SEWAGE DISPOSAL SYSTEM

A REPAIR

ADDRESS 2555 Jennings Chapel Road, Woodbine, Maryland 21797 PHONE 489-4724

REPAIR - PURPOSE - To Establish Sufficient Syptic System Capacity for the Proposed Addition.

*1 Story addition*

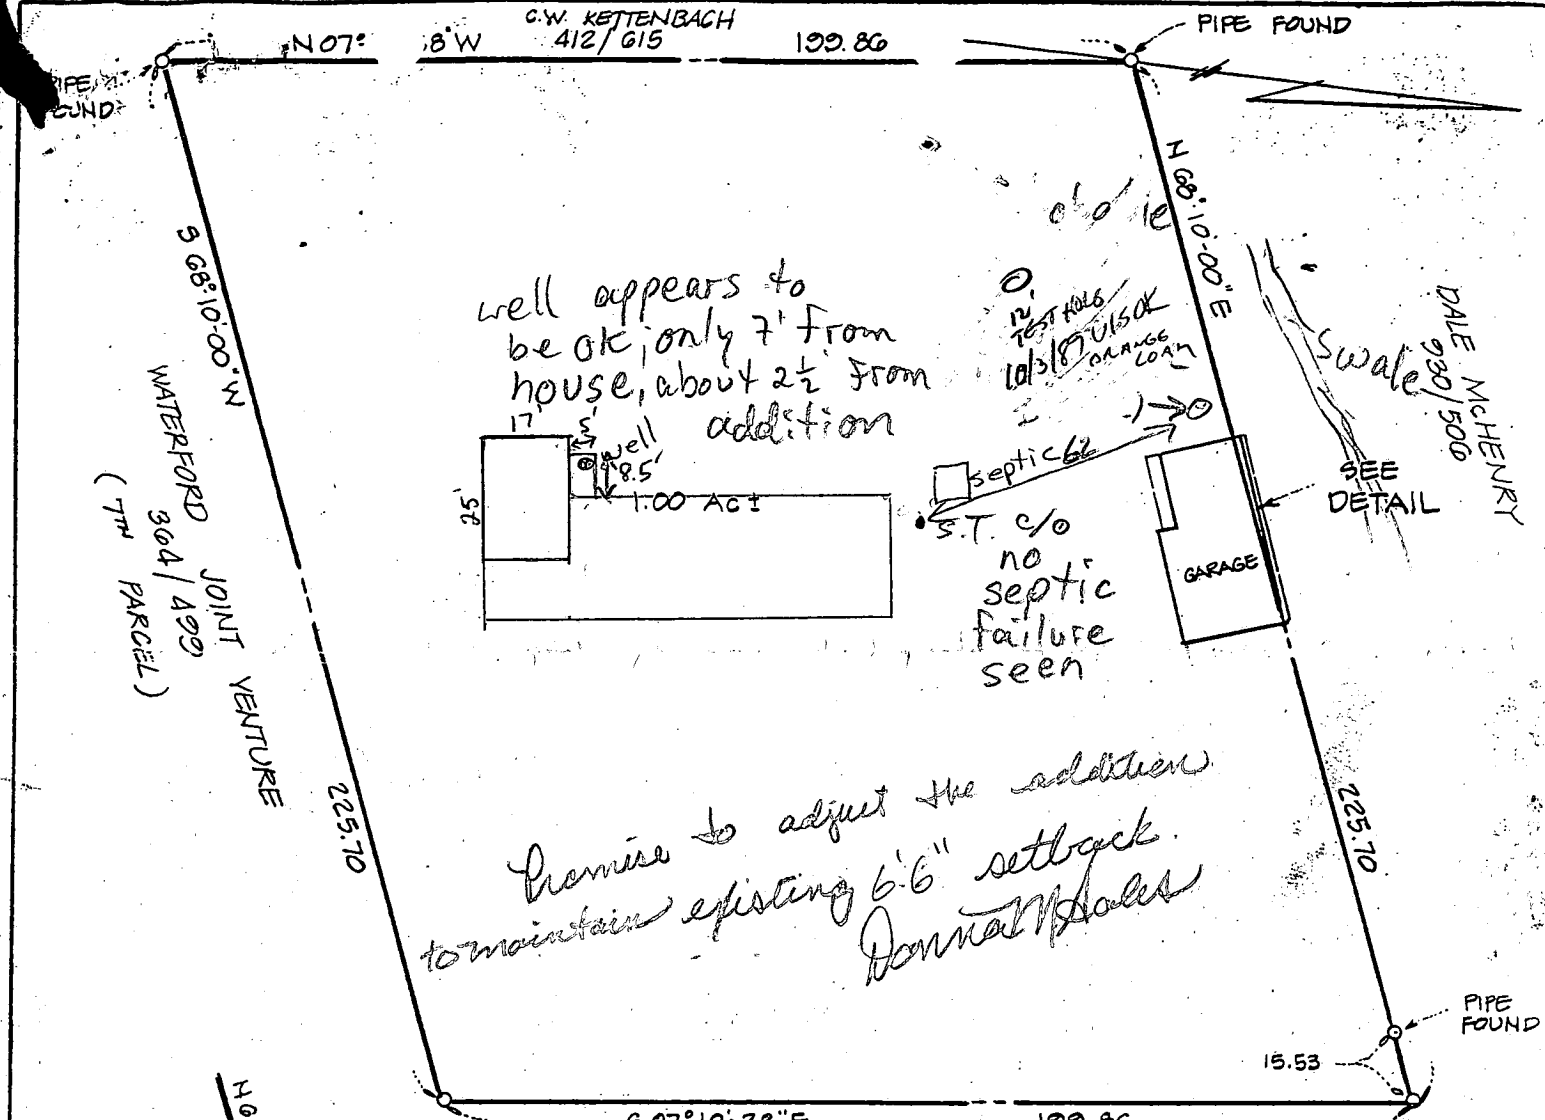
REMARKS CONTRACTOR (SIRK) INDICATES ORIGINAL SYSTEM 25 YRS OLD,

1000 GAL TANK, CONCRETE AND 2-75' SHALLOW TRENCHES,

NO EVIDENCE OF FAILING AT THIS TIME,

APPLICANT ADVISED TO PUMP TANK AND CONSIDER EXPANDING SYSTEM, BUT NOT REQ. D,

ADDITION TO BE NO CLOSER TO EXISTING WELL THAN CURRENT STRUCTURE,

SOME GRACE WILL BE GRANTED IF WELL CASING EXTENDED, AND PIT ELIMINATED. CW,

Promise to adjust the addition to maintain existing 6'-6" setback.  
 Donna M. Hales
